Access Compliance Report

Public Rights-of-Way

Intersection ID: 27270	Main Street: ELMSTONE_DR	Cross Street: SUMMITT_TREE_CT	Location: NW
ADA ID: F5EB3B08065C	Ramp Type: PerpDiag	Initial Pass/Fail: Fail	Overall Compliance: No
		Severity Score: 37.5

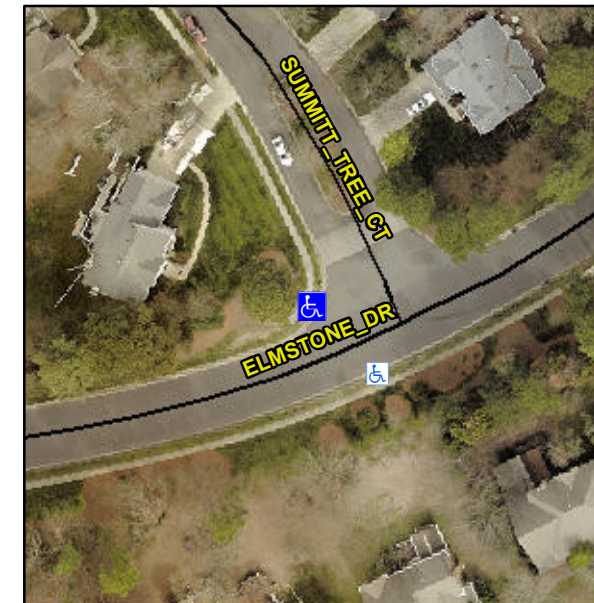
Not Found, R304.2.2, R304.5.3

Compliance	Description	Data	Compliance	Description	Data
N/A	Ramp Length (in)	46.0	No	Ramp Slope (%)	12.2
Yes	Ramp Width (in)	48.0	No	Ramp XSlope (%)	6.0
N/A	Flare Type LT	N/A	N/A	Flare Type RT	N/A
N/A	Flare Slope LT (%)	N/A	N/A	Flare Slope RT (%)	N/A
N/A	Flare Traversable LT?	N/A	N/A	Flare Traversable RT?	N/A
N/A	Landing Length (in)	N/A	N/A	DWS Provided?	N/A
N/A	Landing Width (in)	N/A	N/A	DWS Contrast?	N/A
N/A	Landing Slope (%)	N/A	N/A	DWS Length (in)	N/A
N/A	Landing X Slope (%)	N/A	N/A	DWS Full Width?	N/A
N/A	Landing Curb? (Y/N)	N/A	N/A	DWS Offset (in)	N/A
N/A	Shared Landing?	N/A			
N/A	Gutter Ponding?	N/A	N/A	Gutter Slope (%)	N/A
N/A	Gutter Lip Ht (in)	N/A	N/A	Gutter X Slope (%)	N/A
N/A	Painted X Walk1?	No	N/A	Painted X Walk2?	No
	X Walk 1 Direction	To SE		X Walk 2 Direction	To NE
N/A	X Walk 1 Width (in)	N/A	N/A	X Walk 2 Width (in)	N/A
	X Walk 1 Slope (%)	3.9		X Walk 2 Slope (%)	9.7
	X Walk 1 X Slope (%)	6.2		X Walk 2 X Slope (%)	1.0

Remove & Replace Curb Ramp With Two New Directional Ramps or Equivalent.
